Product Change Notification

Product Name: WAFER-BT-i1 SBC

This notice is to inform you of changes to the WAFER-BT-i1 SBC series

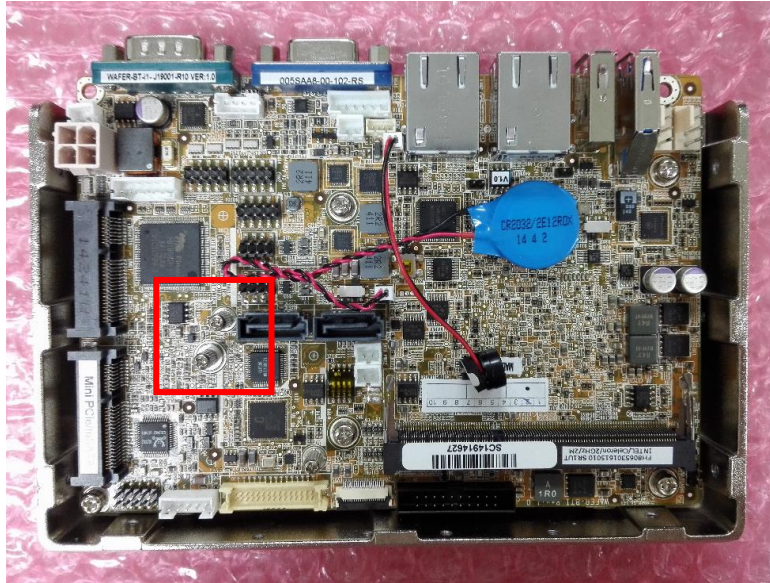
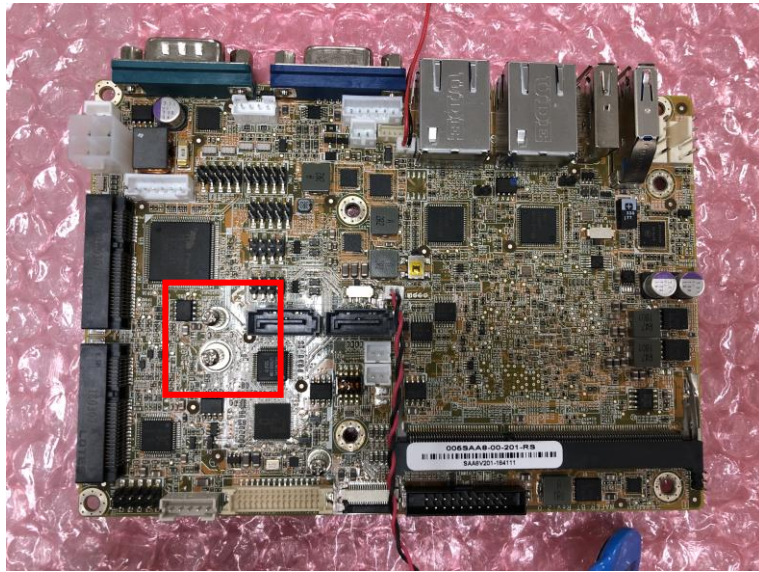
1. Bay Trail CPU stepping change.
2. Remove iRIS slot.
3. Add one half size mini-PCIe slot
4. Colay terminal block with power connector.
5. Improve product compatibility by supporting LVDS brightness control and ErP.
